Grants Reclamation Project

RE: **Grants Reclamation Project** – Cibola County, NM
Homestake Comments on "Focused Review of Specific Remediation Issues -
An Addendum to the Remediation System Evaluation for the Homestake Mining
Company (Grants) Superfund Site, New Mexico" – February 2010

**Homestake Mining Company's Response to
Recommendations Contained in the U.S. Army Corps of Engineers'
Focused Review of Specific Remediation Issues:**

**An Addendum to the Remediation System Evaluation for the Homestake Mining
Company (Grants) Superfund Site, New Mexico (Draft Report, February 2010)**

Figure 1. Conceptual performance of the large tailings pile with and without flushing.

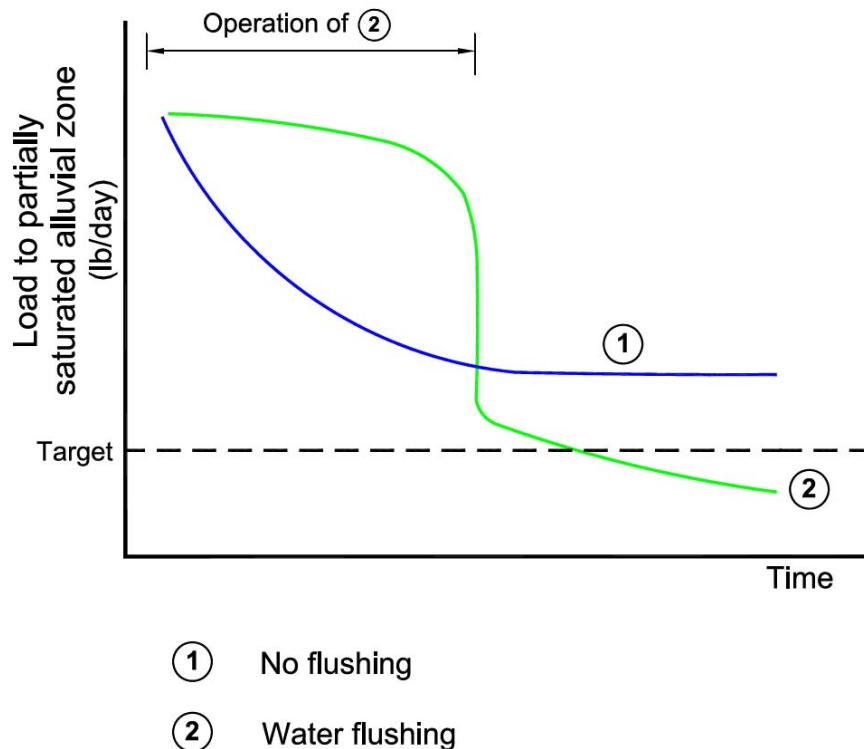
Figure 1 depicts that, although uranium concentrations in the partially saturated alluvial zone beneath the tailings pile remain elevated for a period of time during flushing (line labeled “2” in Figure 1), the load to the partially saturated alluvial zone beneath the tailings is much more effectively controlled. Flushing provides a means to achieve concentrations well below the target corresponding to a concentration of 2 milligrams per liter (mg/L) underneath the tailings. Without flushing, uranium load drops off gradually, but concentrations remain high and, due to continual draindown of pore water with elevated concentrations of uranium, the target is never achieved (line labeled “1” in Figure 1). The Executive Summary of the ACOE report states as one of the conclusions that the seepage modeling likely overestimates the efficiency of flushing of the tailing; however, this is not the case. The model has been able to represent performance of the flushing program. There is currently a slight lag between actual and predicted performance because of the inability to flush at full capacity due to the lack of adequate evaporative capacity; however, this is not a function of model predictability and reliability. The flushing program can now proceed as planned in light of the recent approval of DP-725 and construction of Evaporation Pond 3 (EP-3).

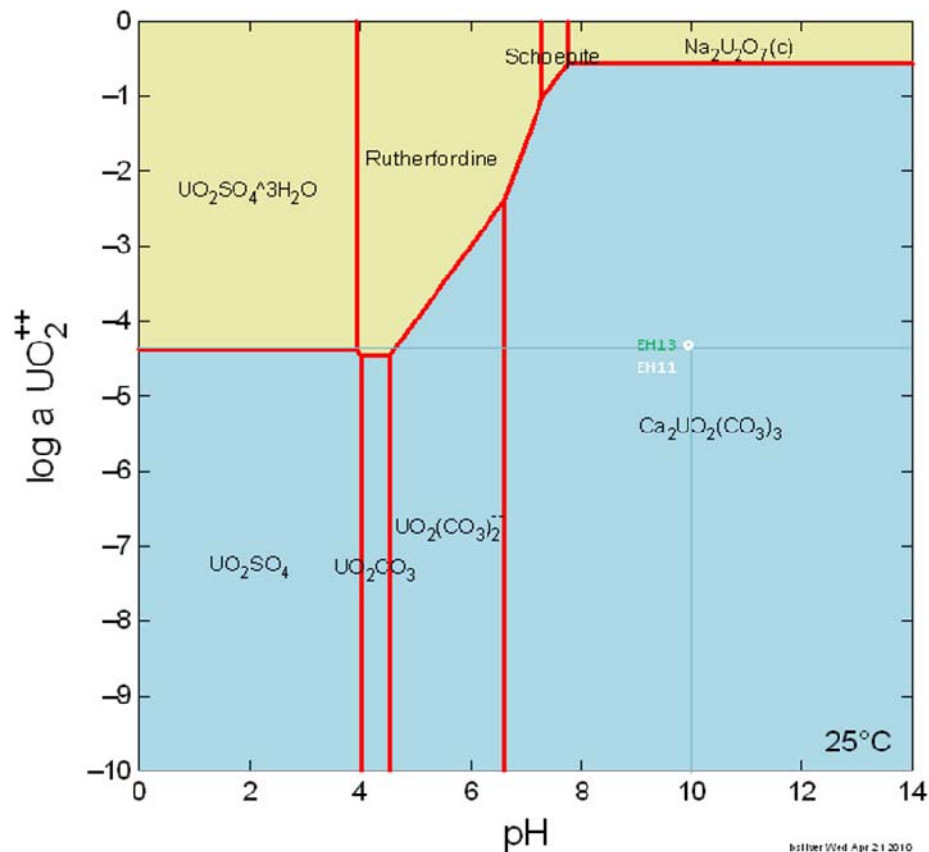
Geochemical modeling indicates that, at the pH of the pore water (pH 10), uranium is present as the soluble calcium uranium carbonate complex (Ca₂UO₂(CO₃)₃) in the tailings pore water. The soluble forms of uranium are dominant in the tailings pore water due to the excess of bicarbonate relative to uranium (Table 1), and similar concentration of calcium. Under these conditions, it is highly unlikely that any solid phase uranium can persist beyond the completion of flushing and remain available for re-dissolution. Studies have shown that uranium present as uranyl carbonate or calcium uranium carbonate is very poorly sorbed by solid mineral phases (Zheng et al. 2003), and this further supports the conceptual model based on soluble uranium resident in tailings pore water. Uranium solid phases are under-saturated (prone to dissolution), and are not expected to form at the uranium concentration and pH conditions in the pore water (solid phase forms of uranium are depicted in Figure 2 as yellow areas; soluble uranium is shown as blue areas).

Figure 3. Conceptual remedial performance of the large tailings pile with and without flushing, and with flushing and an augmentation approach.

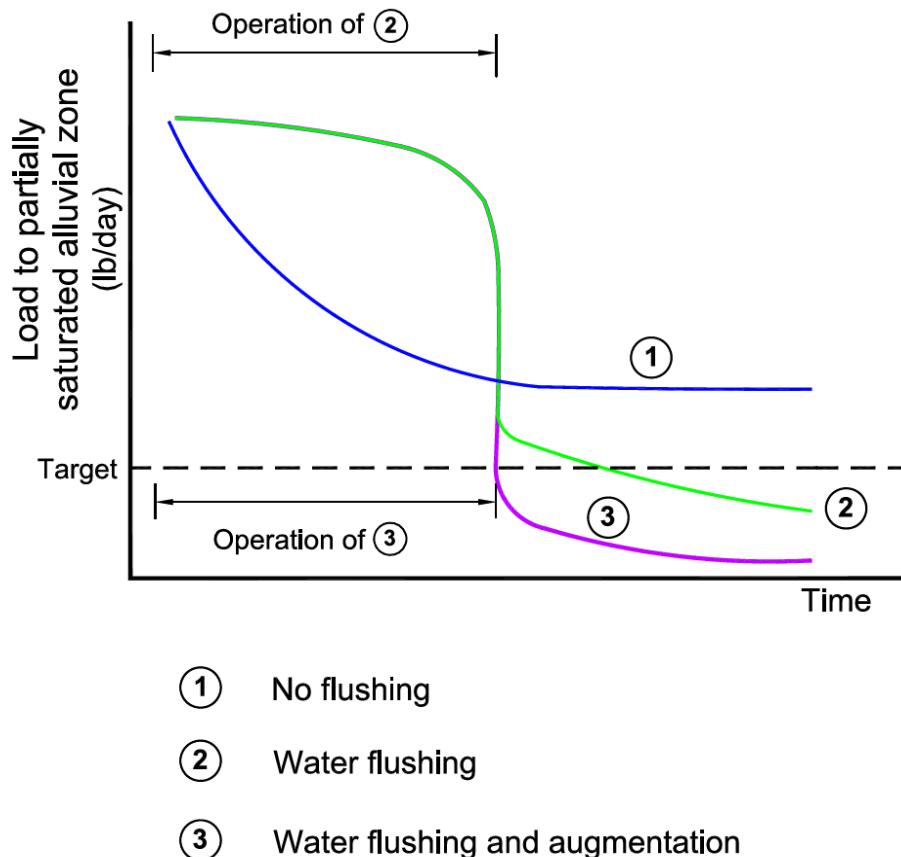
With respect to ACOE's evaluation of an in-situ immobilization approach, continuation of the flushing program will provide the ability to transition to an approach to stabilize uranium leaching to the partially saturated zone through an augmentation program if determined appropriate. The augmentation program may be implemented at the appropriate time when it can be most effective, after flushing has been completed. Figure 3 illustrates the potential benefit of an augmentation approach.

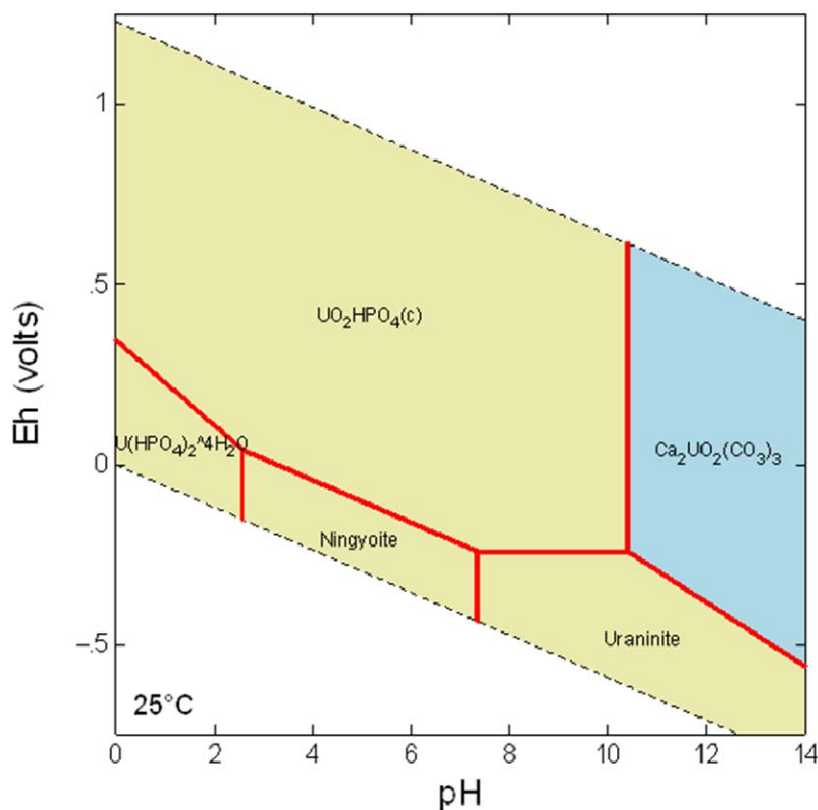
Because of the known occurrence and relatively low permeability of fine-grained materials (slimes) in the large tailings pile, and the presence of dissolved uranium in the slimes, an option is to create insoluble forms of uranium through the addition of a phosphate amendment. A preliminary geochemical modeling evaluation has been performed for the current uranium chemistry prevalent in the large tailings pile. The aqueous geochemistry data for wells EH-11 and EH-13 indicate that the prevalent forms of uranium in the tailings are soluble uranyl carbonates (Figure 2). A phosphate amendment (HPO_4^{3-}) was simulated and the minerals and aqueous species with a phosphate treatment solution were found to be stable over most of the pH range. This was simulated through a geochemical modeling evaluation of the addition of phosphate to the tailings (Figure 4). These initial conclusions suggest that the flushing of the tailings should be continued to remove the soluble uranium present in the slimes, then the remaining low levels of uranium could be fixed by introduction of a phosphate amendment to form insoluble uranium phosphate minerals, or another amendment that is proven to assist in remediation. The modeling results, therefore, validate that an in-situ immobilization approach using sodium tripolyphosphate (reviewed by the ACOE in Section 4.4.3) is feasible; this will be

further evaluated for application to the partially saturated alluvial zone underneath the tailings, and for groundwater where the geochemical conditions are also suitable for its application.

Figure 5. Mass of uranium removed by the large tailing pile extraction wells and toe drains and decreasing uranium concentrations.

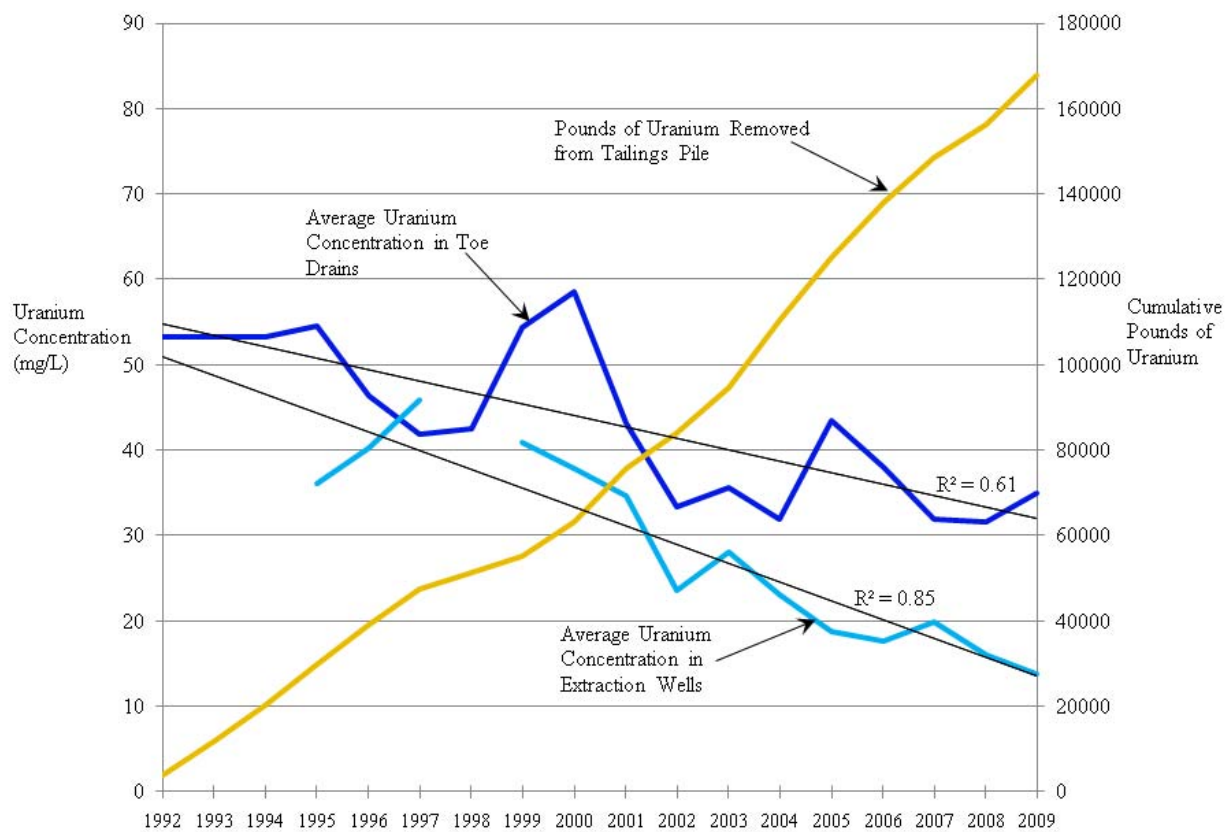
The effectiveness of the combined flushing and extraction system can be measured by the mass of uranium removed from the tailings. A graph of the total mass of uranium removed by the toe drains along the perimeter of the tailings pile and extraction wells in the tailings since 1992 is provided as Figure 3. The toe drains began in 1992, whereas the extraction wells began operation in 1995. The cumulative mass of uranium removed from the tailings reached approximately 170,000 pounds by the end of 2009, and the removal rate has been relatively steady through time, indicating that the system continually removes a substantial amount of uranium in addition to other constituents such as sulfate, molybdenum, and selenium that also have similar and steady removal rates. This amount of uranium is no longer available to leach and migrate into the alluvial aquifer.

The effectiveness of the system is also measured in the overall reduction in uranium concentration within the tailings pile. The annual average uranium concentrations in the extraction wells and toe drains are shown on Figure 5. Uranium concentrations from the extraction wells have decreased from around 40 to 14 mg/L, or an approximate 65 percent reduction since 1995. The decrease in concentrations from extraction wells is steady. A regression trend line was fitted to the extraction well concentration data with a coefficient of determination (R^2) value of 0.85. The coefficient of determination provides a measure of how well future outcomes are likely to be predicted by the model, and in this case the linear regression line. A value near 1.0 indicates that the regression line perfectly fits the data, and the 0.85 value indicates a good fit. The uranium concentration in the toe drains has decreased from 53 to 30 mg/L, or an approximate 34 percent reduction since 1992. The uranium concentration has fluctuated through time but it has an overall decreasing trend, as depicted by the linear regression line that has an R^2 of 0.61. It is important to point out that the toe drains primarily remove tailings water from the permeable sand dikes, and this has not been the focus of flushing remediation to date. Instead, the focus has been on flushing the tailings slimes through the injection and extractions wells, which addresses the low-mobile mass that is difficult to remove. After the mass is removed from the slimes, the system can then focus on the mobile mass in the tailings sands and this is expected to occur relatively quickly. Overall, the system continues to remove uranium and other constituent mass, and concentrations are steadily decreasing.

Figure 6. Decision support process for sampling optimization

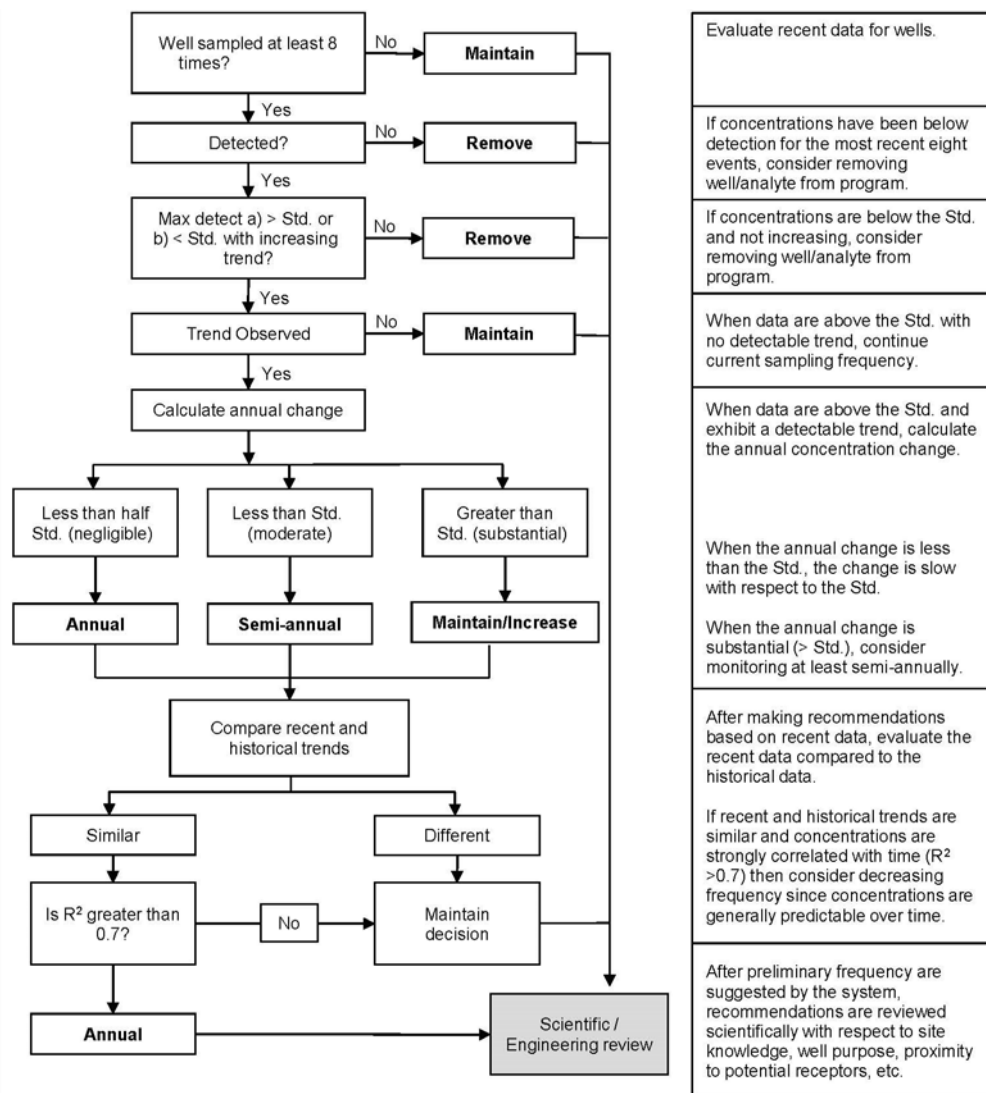
Each well is then subjected to a decision process, and Figure 6 is an example of a commonly used systematic approach for evaluation and optimizing a monitoring program. Data sets are first evaluated to determine that sufficient samples have been collected. Historical and recent trends are evaluated to identify both long-term and short-term concentration trends, and the direction and magnitude of the trend can be evaluated using the relatively simple statistical tests. If no statistically significant trend is detected, the well and constituent is proposed for continued sampling at the current frequency. If a statistically significant trend is identified, the magnitude of change is evaluated with respect to the site standard. In this way, rapidly changing concentrations can indicate an important change in conditions of the plume. Wells with rapidly changing concentrations would be proposed for continued monitoring at the current frequency. Wells with negligible annual change, including those above the site standard, do not benefit from more frequent sampling and are, therefore, proposed for a lower frequency. Moreover, wells with recent trends that are similar to the overall long-term trends can be reduced to annual sampling. Because concentrations are predictable and more frequent sampling does not yield additional information. Final recommendations are subjected to scientific and engineering review to ensure that the proposed sampling program would continue to meet program needs and related permit requirements.

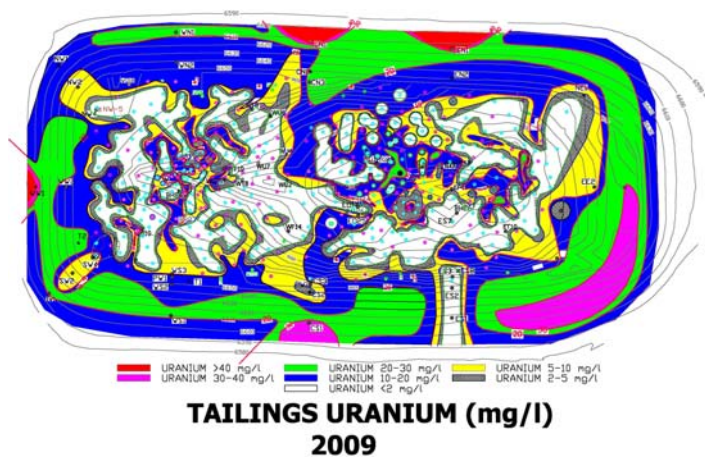
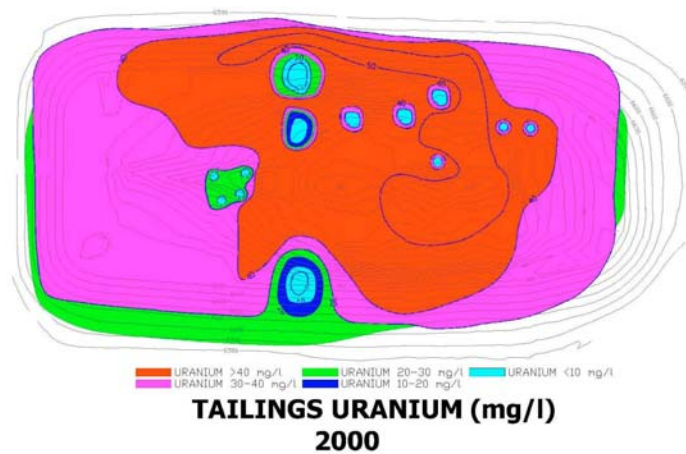
Section 4.1 and Figure 14, Flushing of Large Tailings Pile; page 17. The flushing of the large tailings pile is discussed and Figure 14 is used to show the 2008 uranium concentrations in the tailings. Although the ACOE uses this figure to show the variability of uranium in the pile and illustrate their belief that the flushing has not been effective, HMC believes that the flushing has been effective at removing uranium mass. This is demonstrated by comparing the 2000 and 2009 maps for uranium in the tailings pile, which shows that a significant amount of uranium has been removed. See also HMC’s response to Recommendation No. 2 for additional evidence of the effectiveness of the flushing and extraction program. Below is the 2000 uranium concentration map for the tailings pile showing uranium concentrations exceeding 30 mg/L in much of the pile. Also below is a map of the 2009 uranium concentrations in the pile, which illustrates the significant reduction in concentrations resulting from the flushing and extraction program. For 2009, approximately 67.5 percent of the west side slime area has uranium concentrations less than 5.0 mg/L, and 45.5 percent of the same area has concentrations lower than 2.0 mg/L.
